**DEVELOPMENT PLAN REVIEW - ENGINEERING
COMMERCIAL DEVELOPMENT / SUBDIVISION PERMIT REVIEW CHECKLIST**

CITY TRACKING NO.: _____

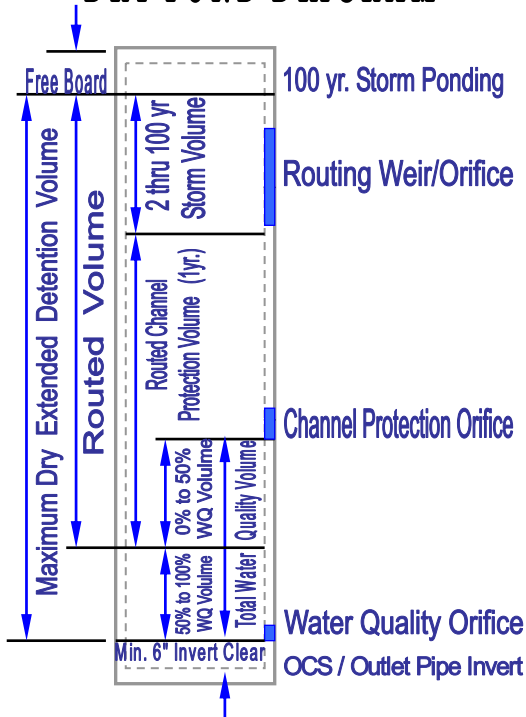
... 98. Orifices less than 3" in diameter must be protected from clogging such as Detail 629. A trash rack (maximum mesh opening of $d/2$) with a surface area of at least 10 square feet shall protect all orifices less than 15" diameter. Provide detail.
